MEMORANDUM

Re: Proposed Hilton Hotel at 620 East River Street

MPC File Number 24-001537-COA

Proposed Amendments to Currently Active C.O.A.

A104

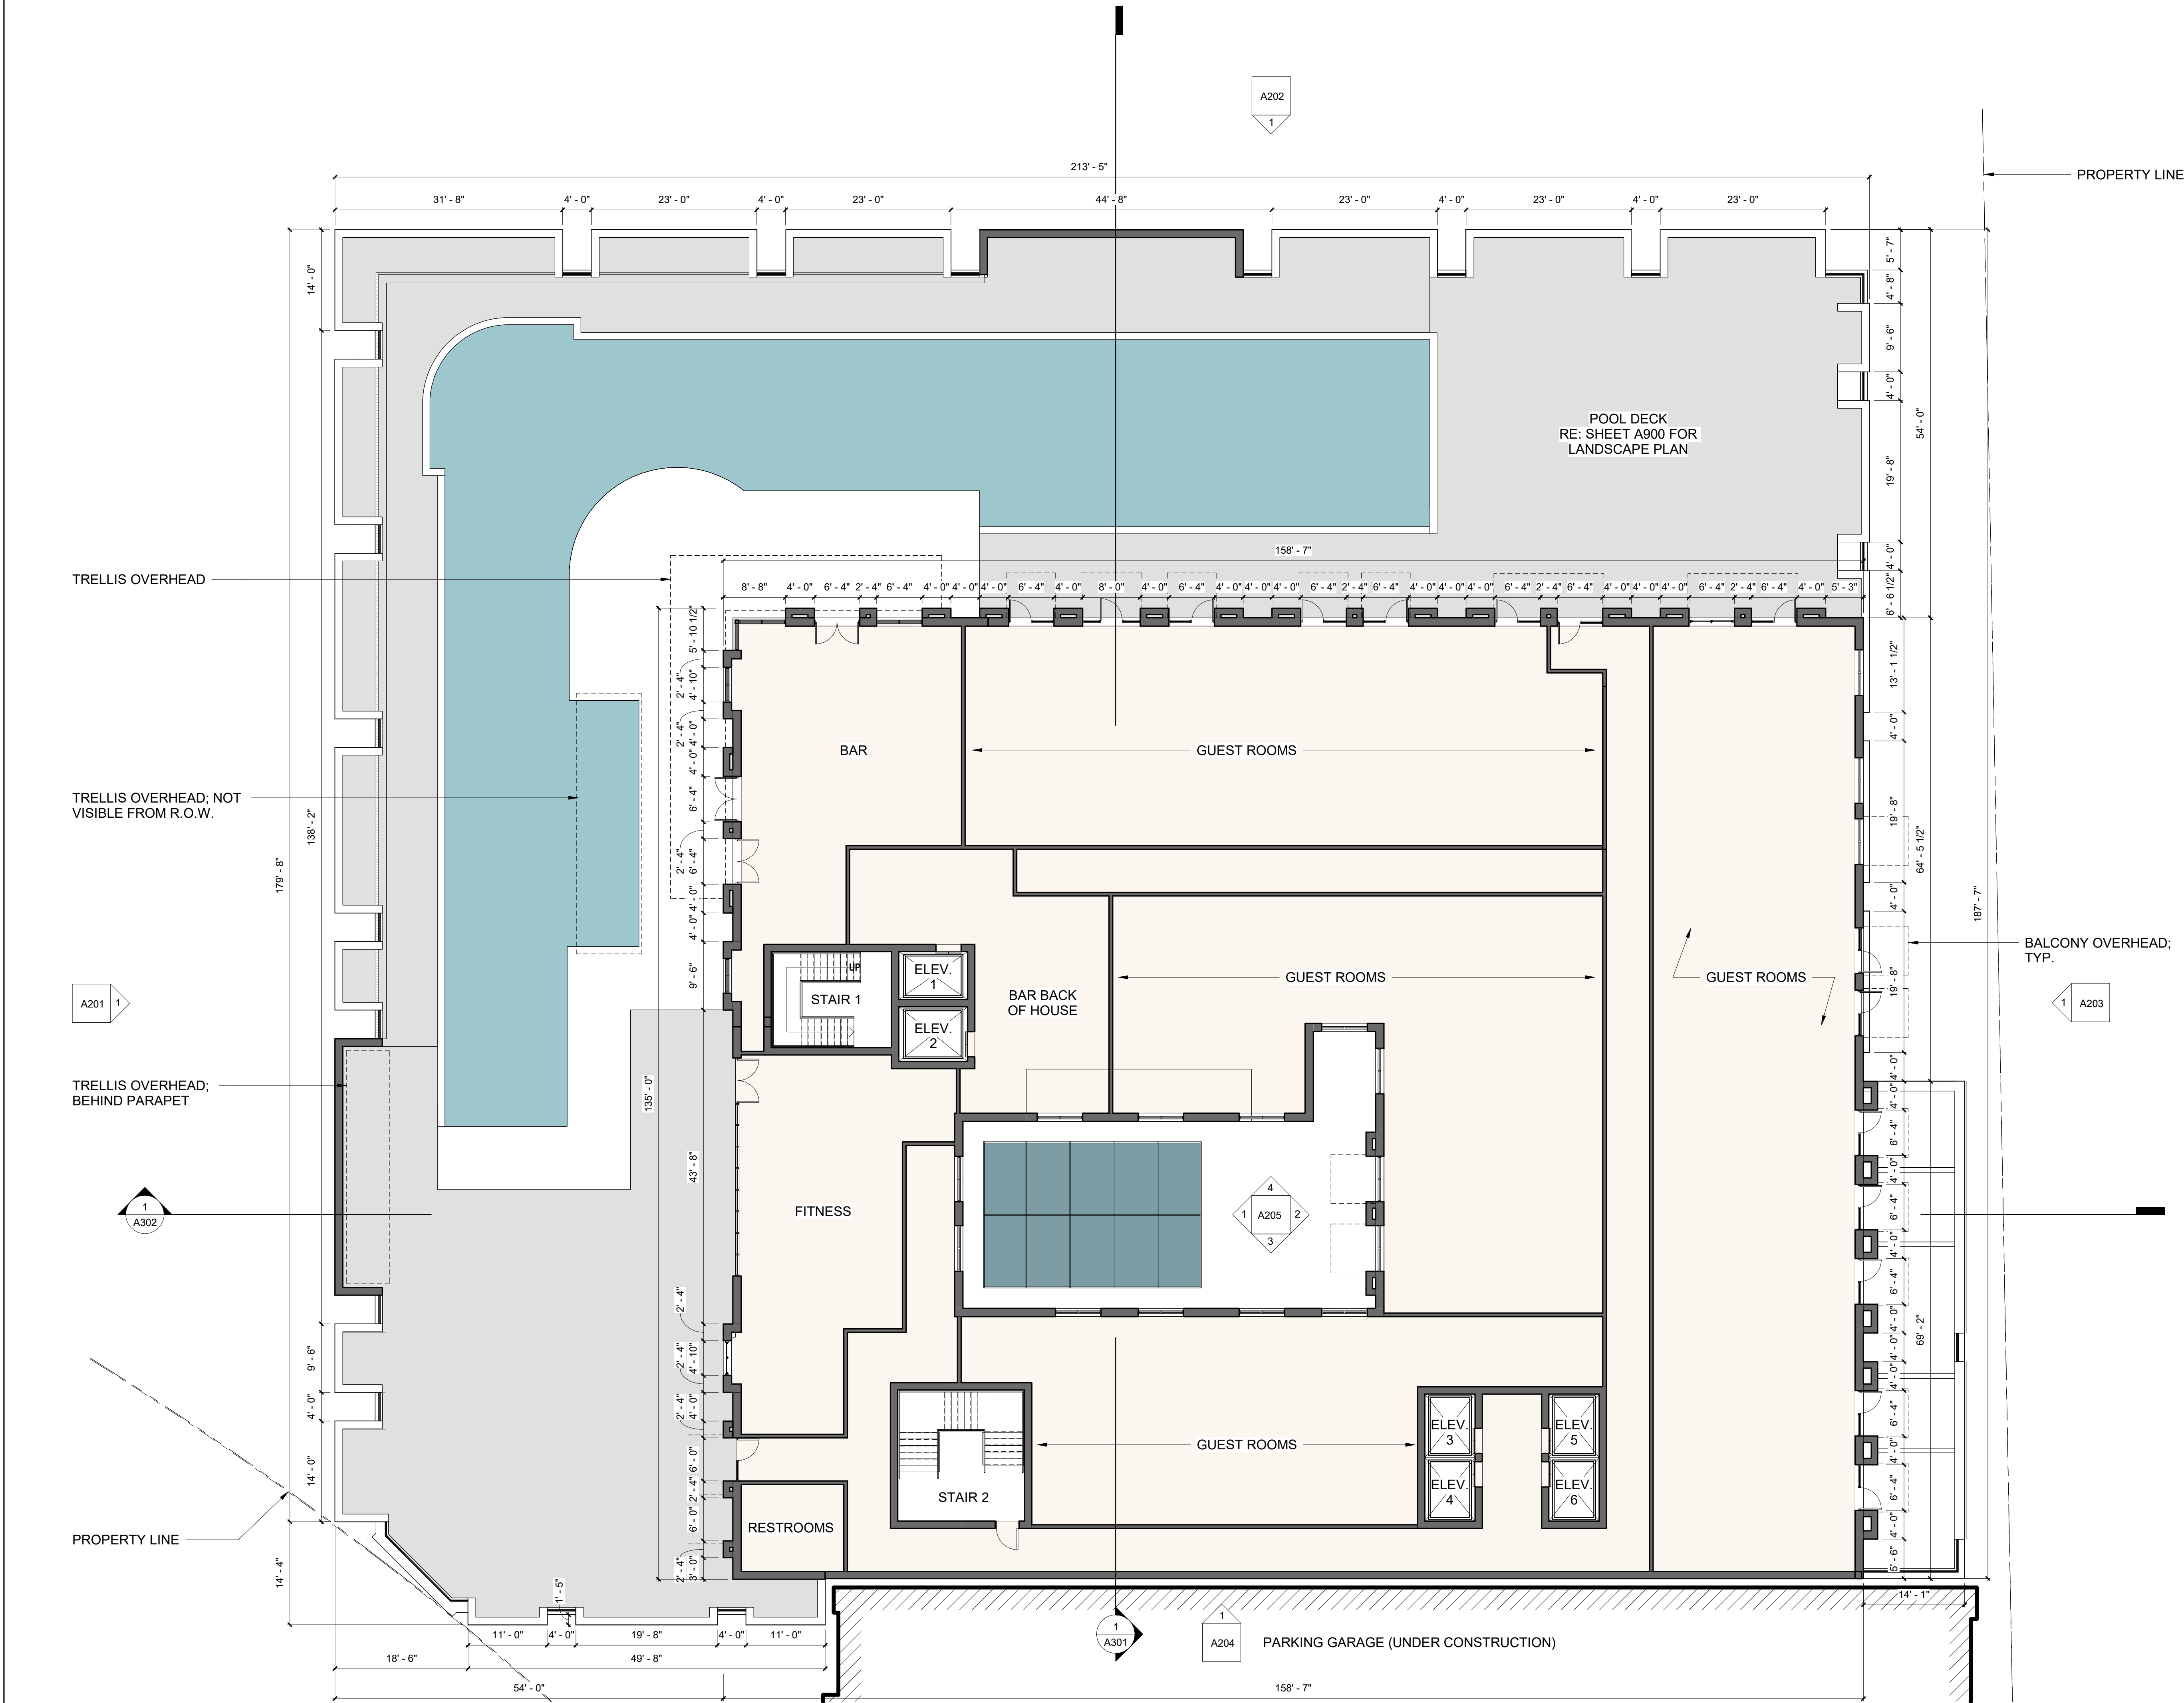
- NOTES:
- AMENITY LIGHTING WILL BE MOUNTED ON THE BUILDING , NOT ON POLES
 - MECHANICAL EQUIPMENT IN CENTRAL AREA IS SCREENED BY BUILDING MASS

A105

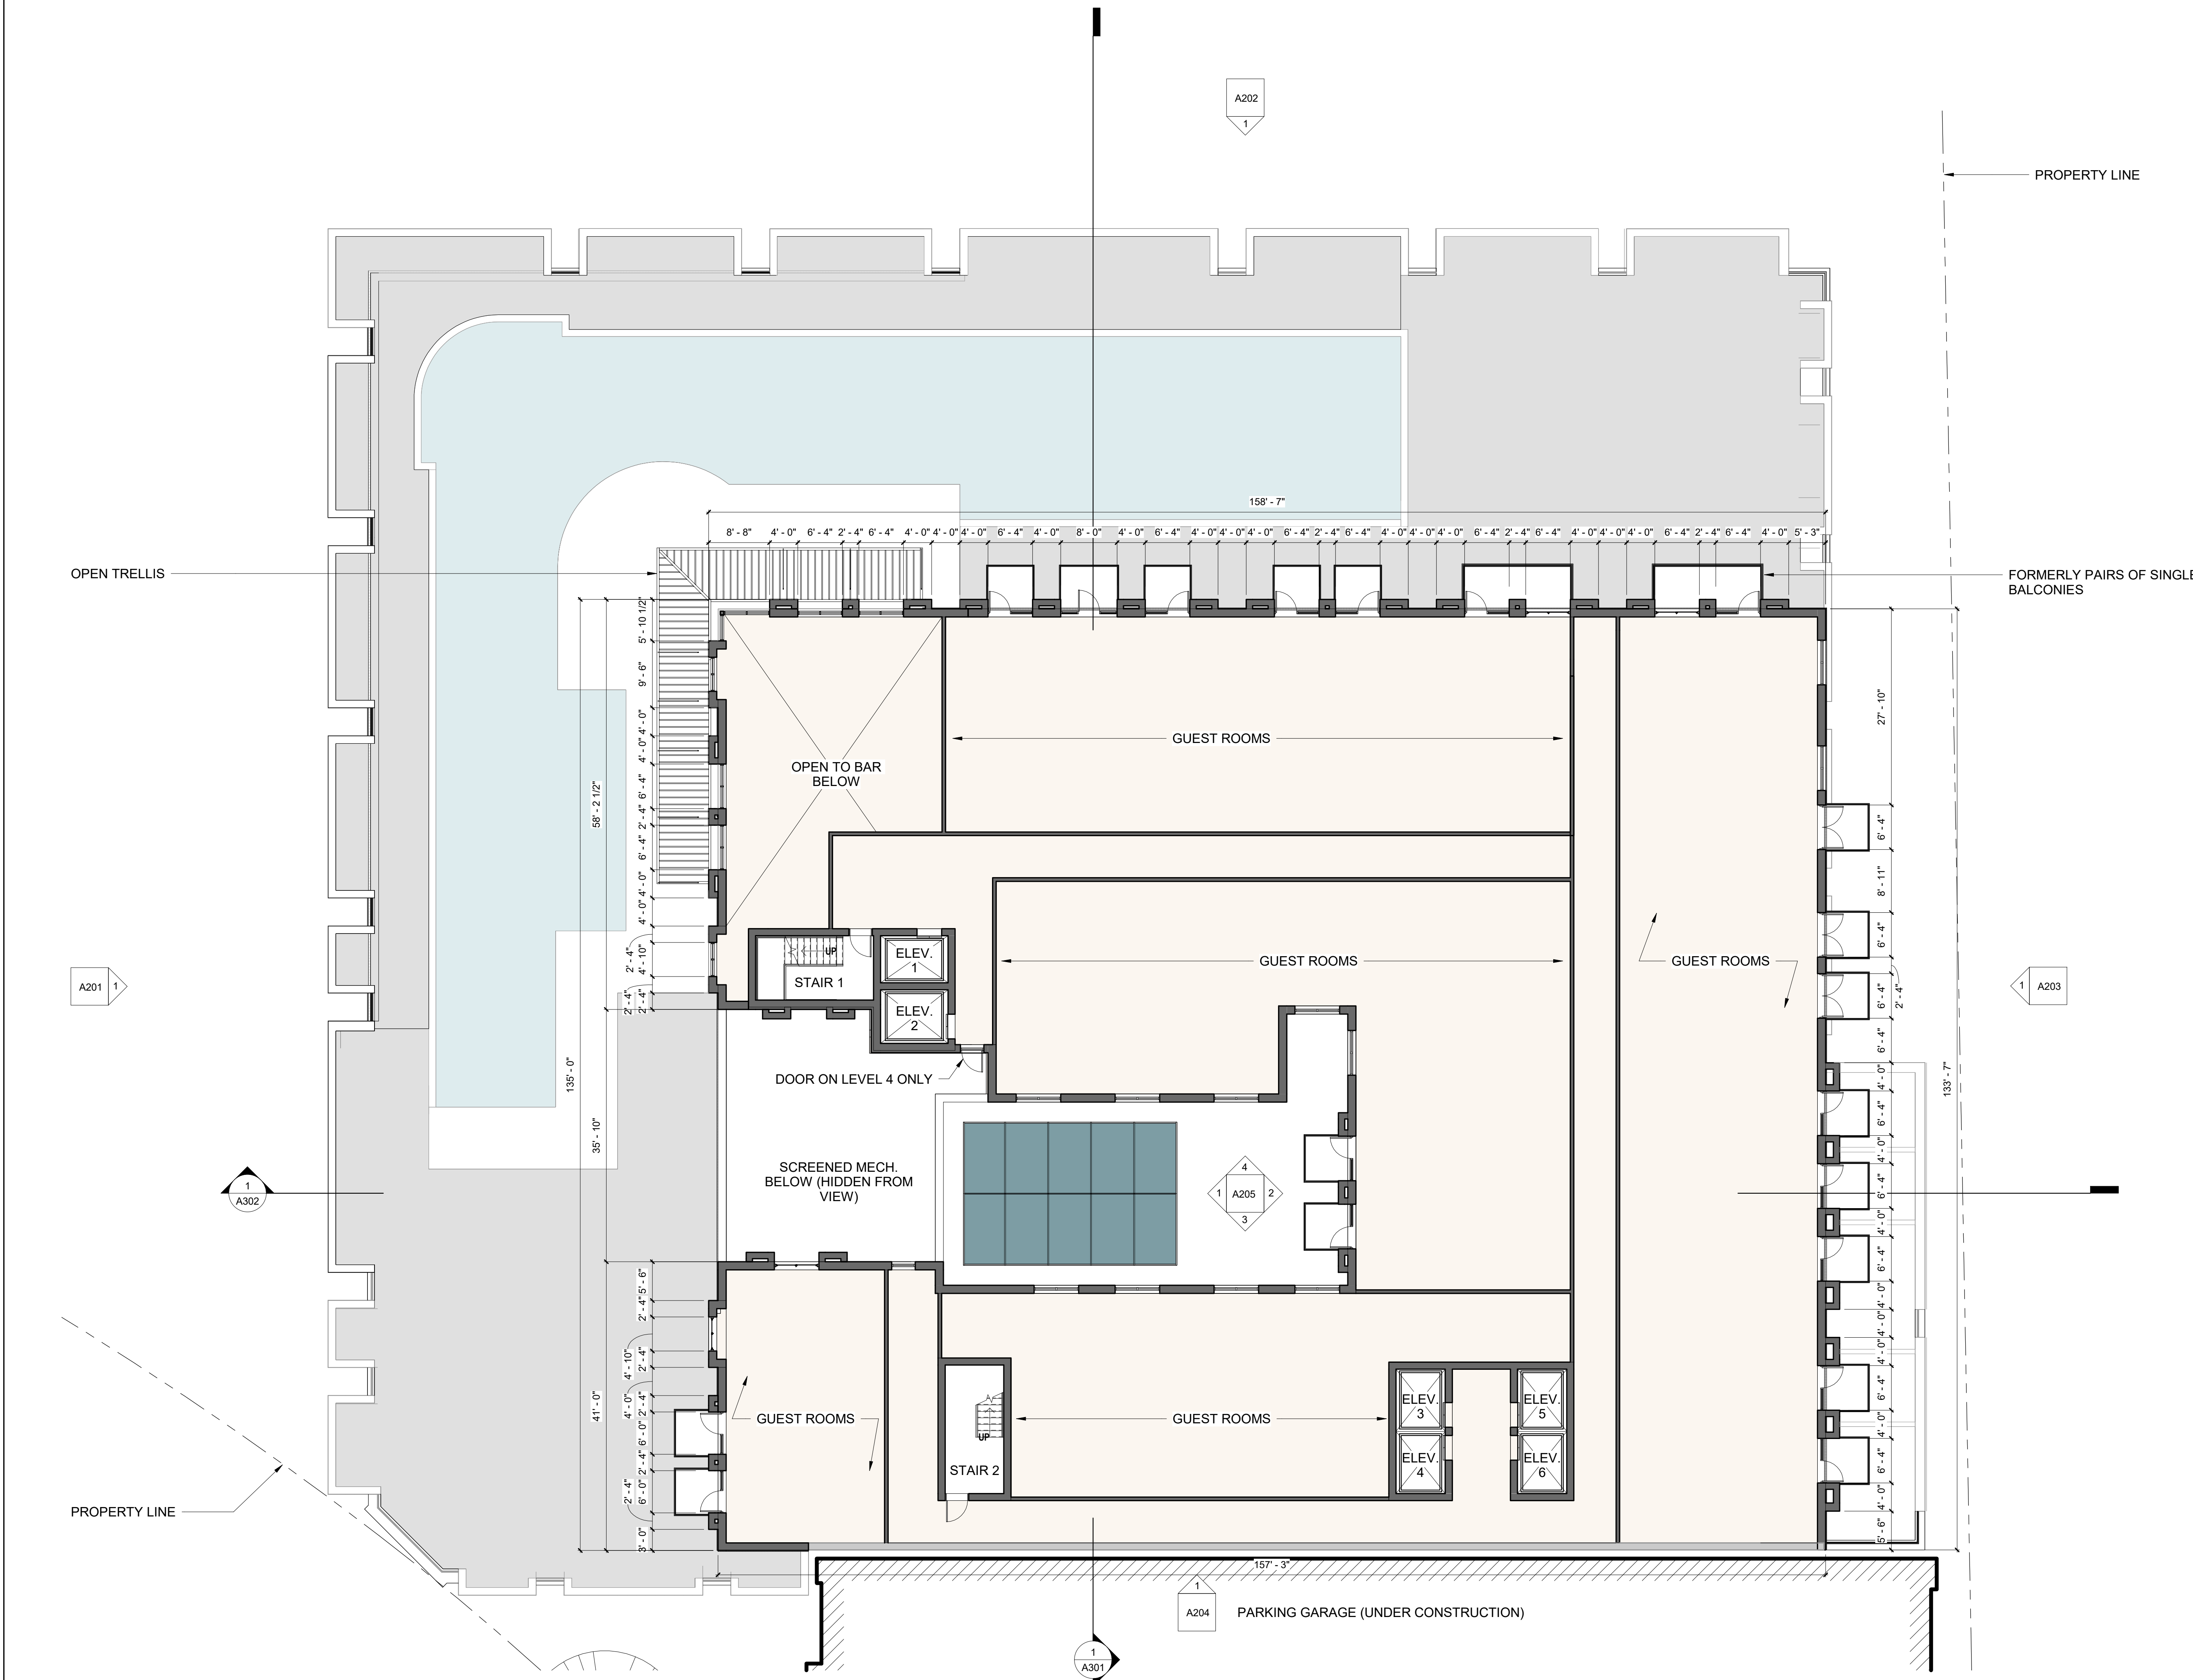
- NOTES:
- AMENITY LIGHTING WILL BE MOUNTED ON THE BUILDING , NOT ON POLES
 - MECHANICAL EQUIPMENT IN CENTRAL AREA IS SCREENED BY BUILDING MASS

A108

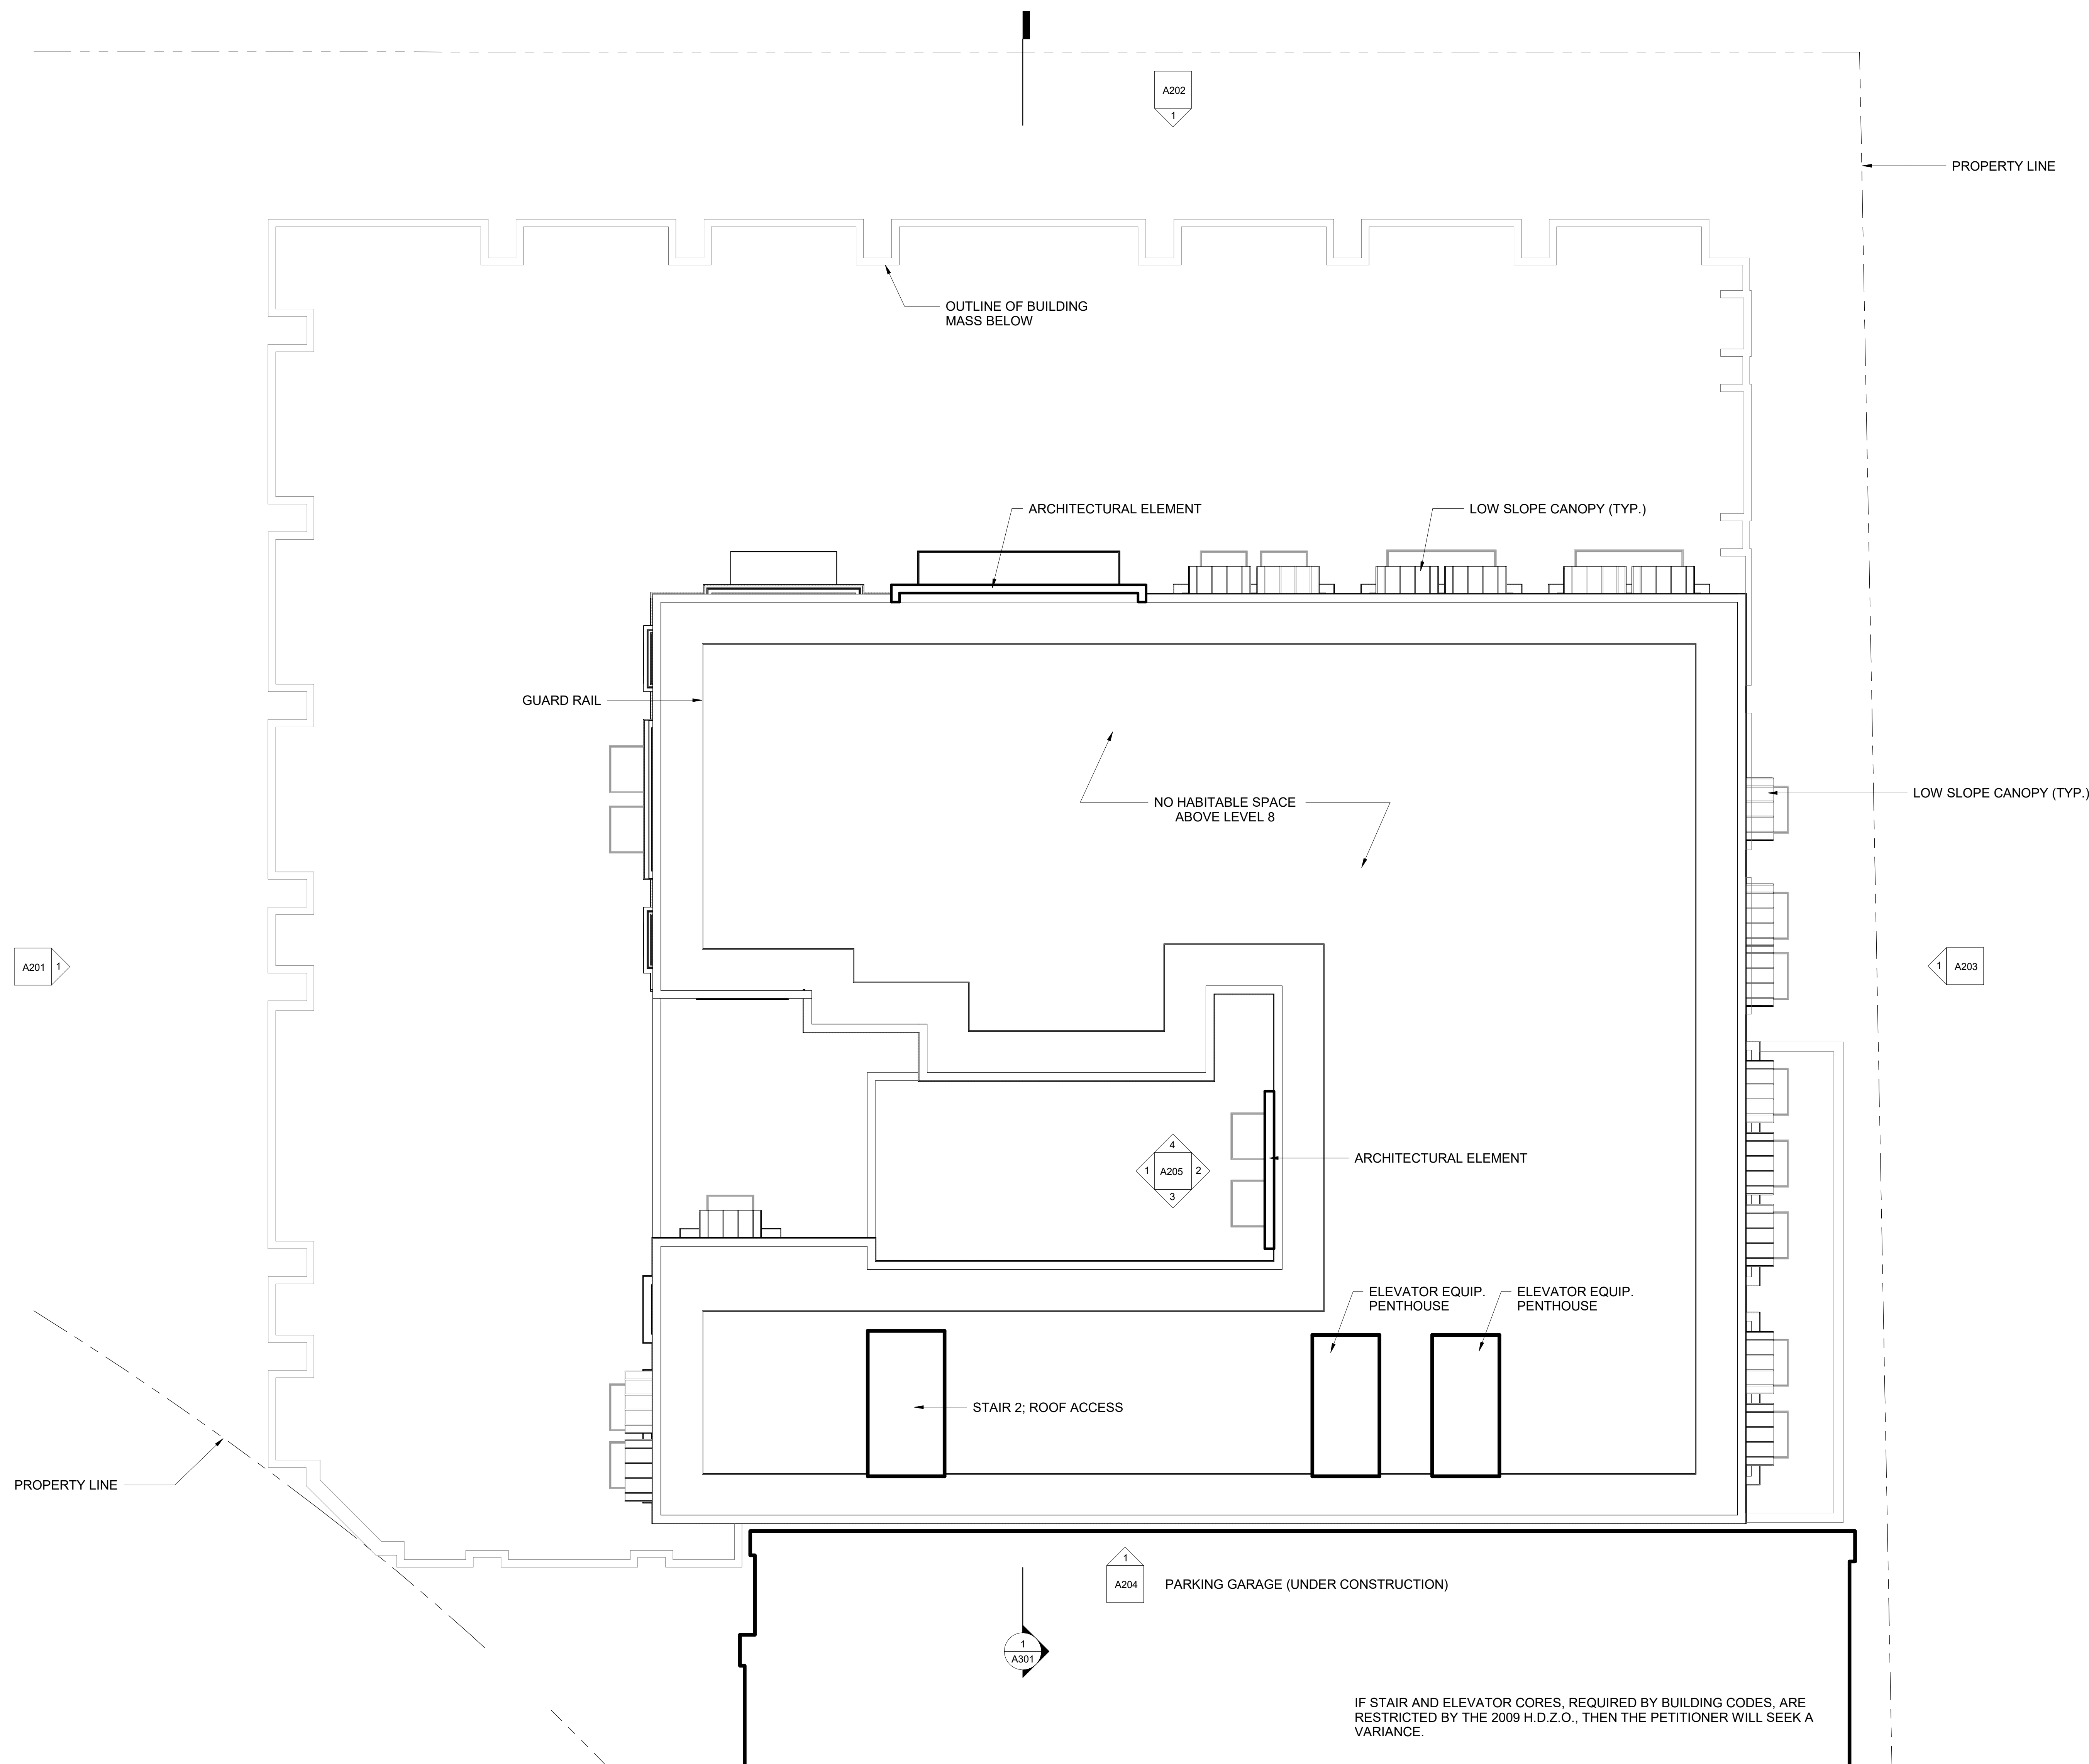
IF STAIR AND ELEVATOR CORES, REQUIRED BY BUILDING CODES, ARE RESTRICTED BY THE 2009 H.D.Z.O., THEN THE PETITIONER WILL SEEK A VARIANCE.
